**From:** Erin.L.Heath@dominionenergy.com  
**Sent:** Friday, July 26, 2024 3:47 PM  
**To:** Keehan, Christopher  
**Cc:** dennis.a.slade@dominionenergy.com  
**Subject:** Dominion Energy updates for SWP 619  
**Attachments:** Attachment III\_Permit Drawings for LAP and UAP Closure\_Rev 07-26-2024.pdf; Attachment IV\_Closure Plans for LAP and UAP\_Rev.2\_07192024.pdf; Attachment IV\_Closure Plans for LAP and UAP\_Rev2\_07192024\_Redline.pdf

DOMINION ENERGY  
CHESTERFIELD POWER STATION  
CLOSURE PLAN - LOWER ASH POND  
PERMIT APPLICATION DRAWINGS  
NOT FOR CONSTRUCTION  
CHESTERFIELD COUNTY, VIRGINIA  
JULY 22, 2024

DOMINION ENERGY  
CHESTERFIELD POWER STATION  
CLOSURE PLAN - UPPER ASH POND  
PERMIT APPLICATION DRAWINGS  
NOT FOR CONSTRUCTION  
CHESTERFIELD COUNTY, VIRGINIA  
JULY 22, 2024

**SURFACE IMPOUNDMENT CLOSURE PLAN (Rev. 2)**

4 TYPICAL CLOSURE BACKFILL DETAIL  
NOT TO SCALE

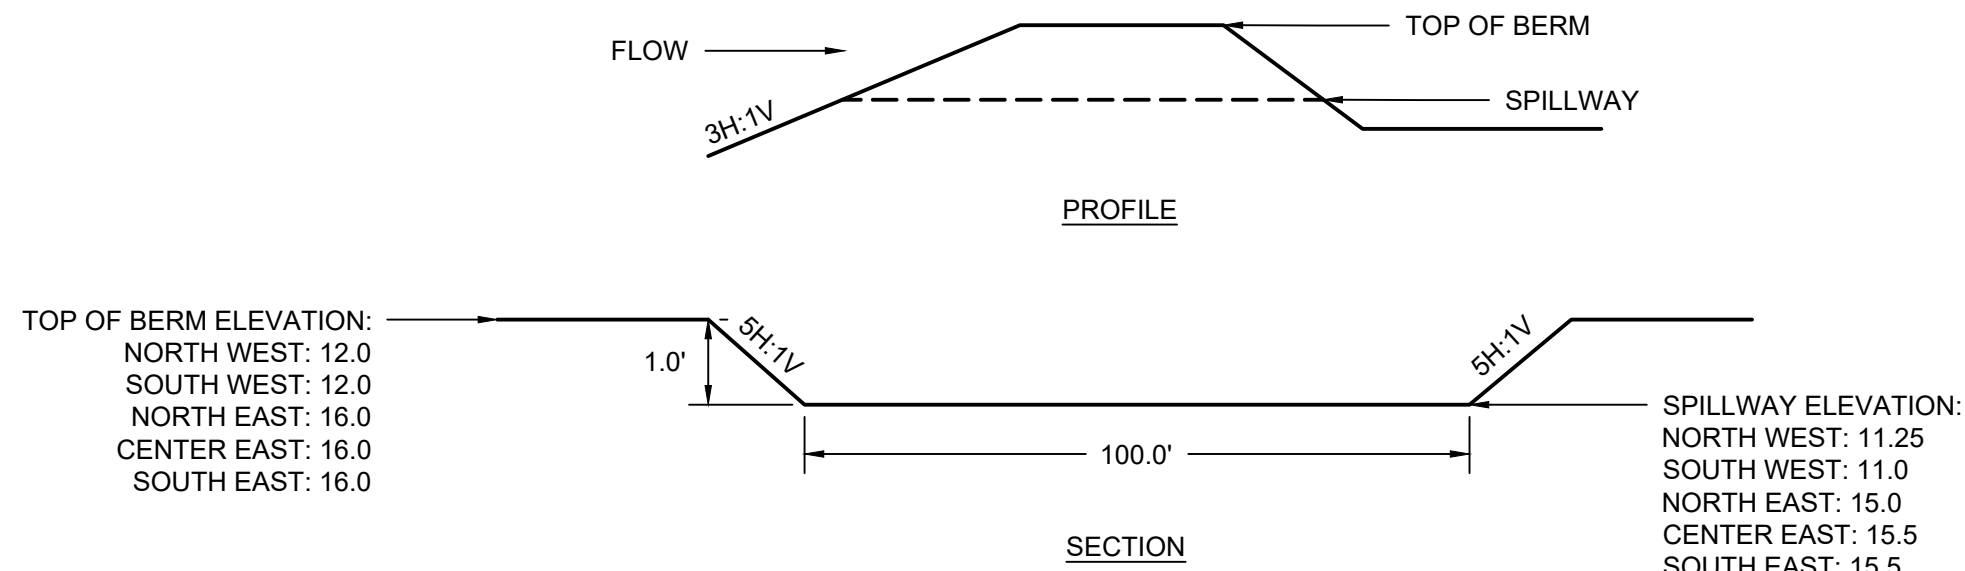
REV NO	DATE	INITIALS	DESCRIPTION
2	7/22/2024	AMC	REMOVE LOW PERMEABILITY FILL FROM BACKFILL DETAIL

2 TYPICAL CLOSURE BACKFILL DETAIL

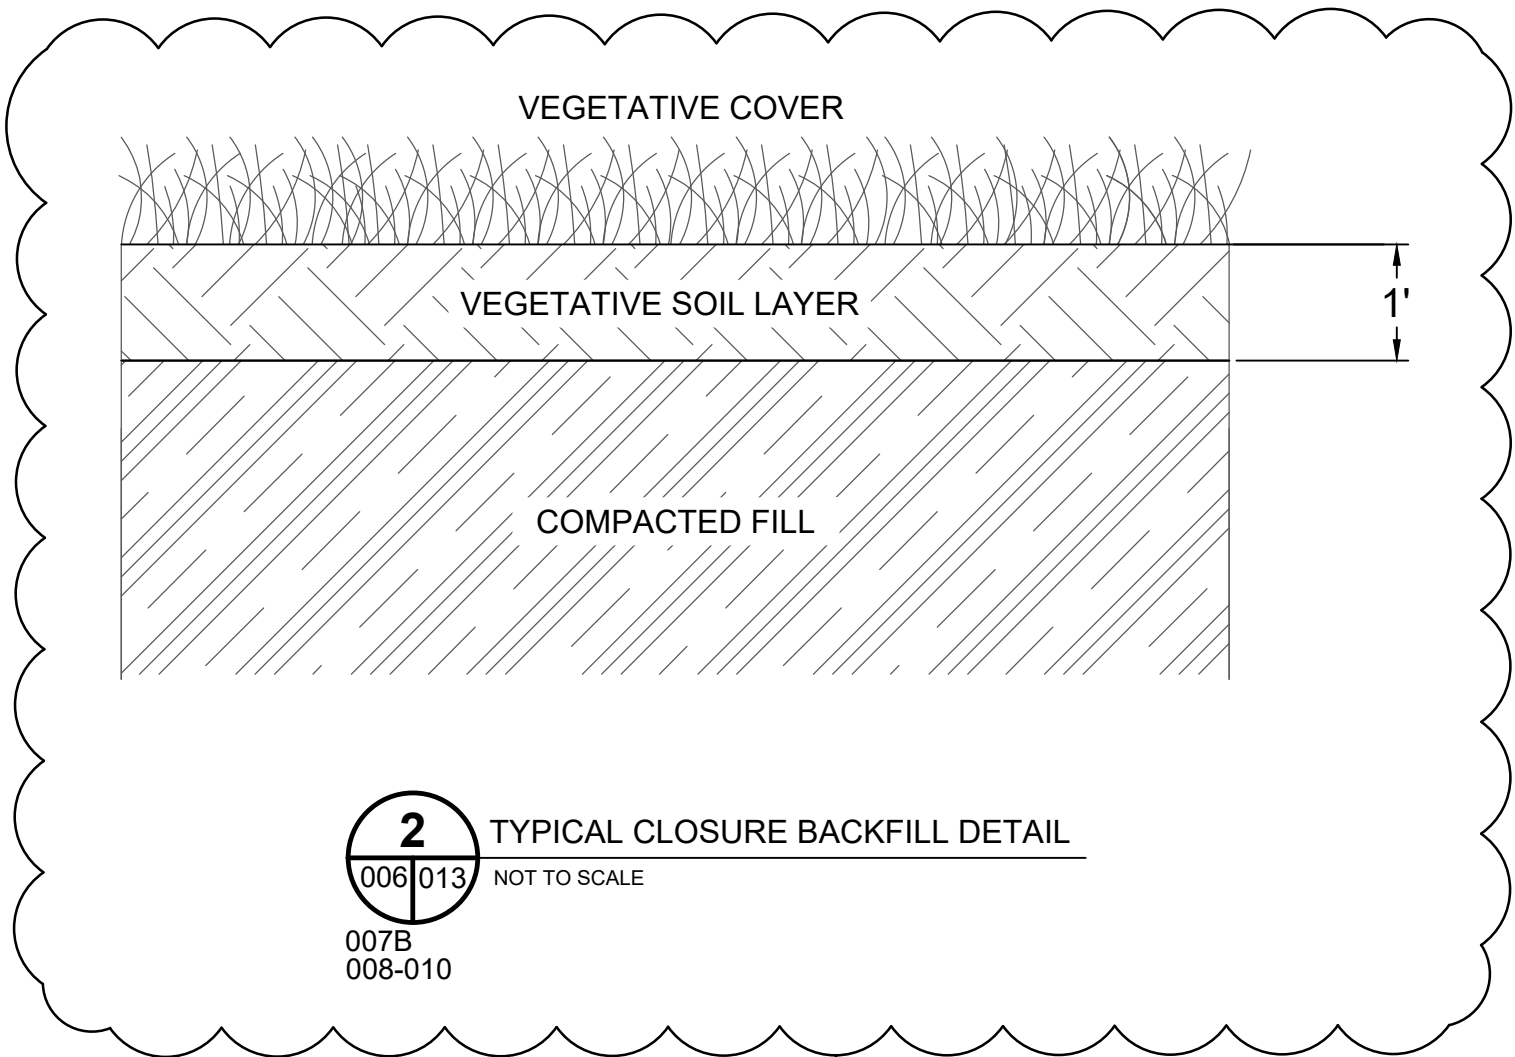
REV NO	DATE	INITIALS	DESCRIPTION
1	7/22/2024	SCW	REMOVE LOW PERM FILL FROM BACKFILL DETAIL
